To All Lamborghini Service Points
From Product Assistance
Page 4
Subject Knocking noise form the torsion bar support.
Group 140.4.01.00.04.TorsionBar.GB
Date 23.02.2005

Knocking noise from torsion bar support front and rear

Gallardo until VIN ZHWG_11_ _4LA01398

Pic 1

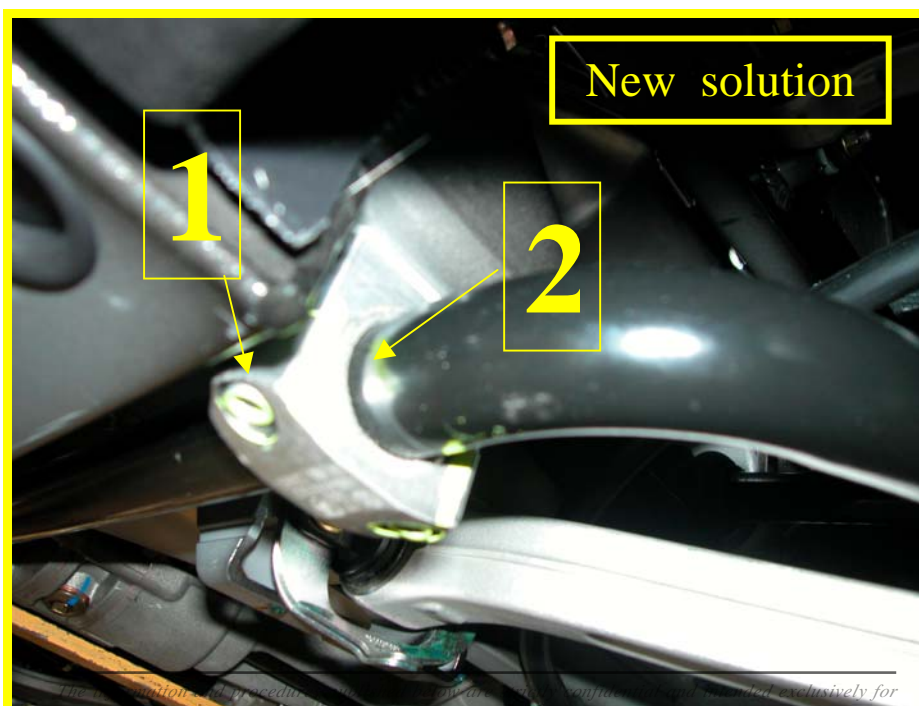
Replace the nylon bushes with new style rubber bushes; it is also requested the replacement of the aluminium brackets with the new ones available at our Spare Parts Dept. . Both front and rear sway bar units remain the ones fitted in the car. See instruction.

Front axle: Rubber bushes (quantity 2 pcs) – 400411324C
Rear axle: Rubber bushes (quantity 2 pcs) – p/n 400511324C

Pic 2

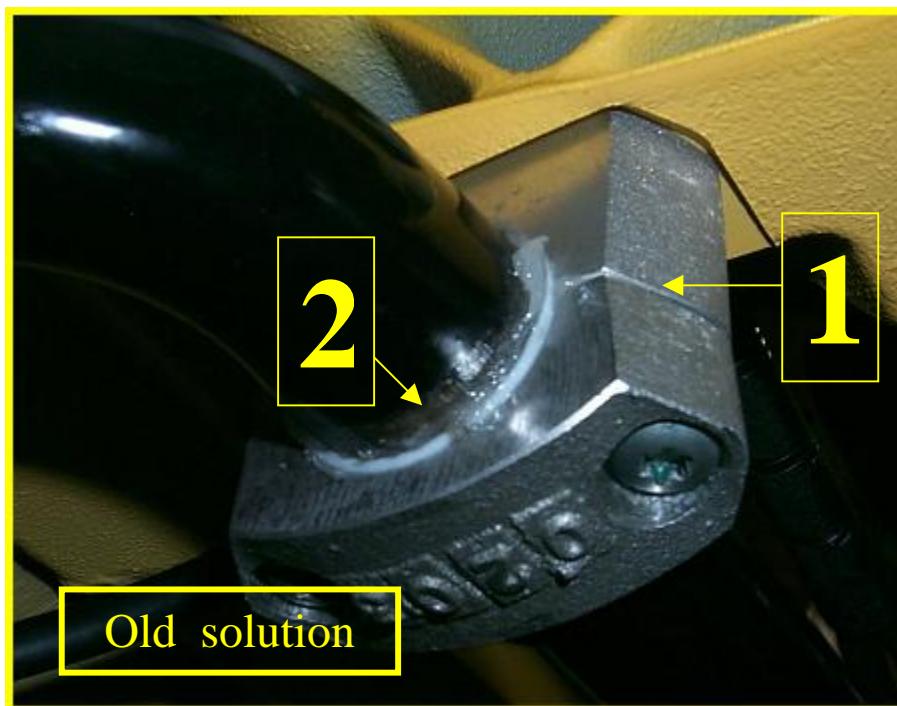
Front axle: Aluminium Brackets (quantity 2 pcs) – p/n 400411031G
Rear axle: Aluminium Brackets (quantity 2 pcs) – p/n 400411031H
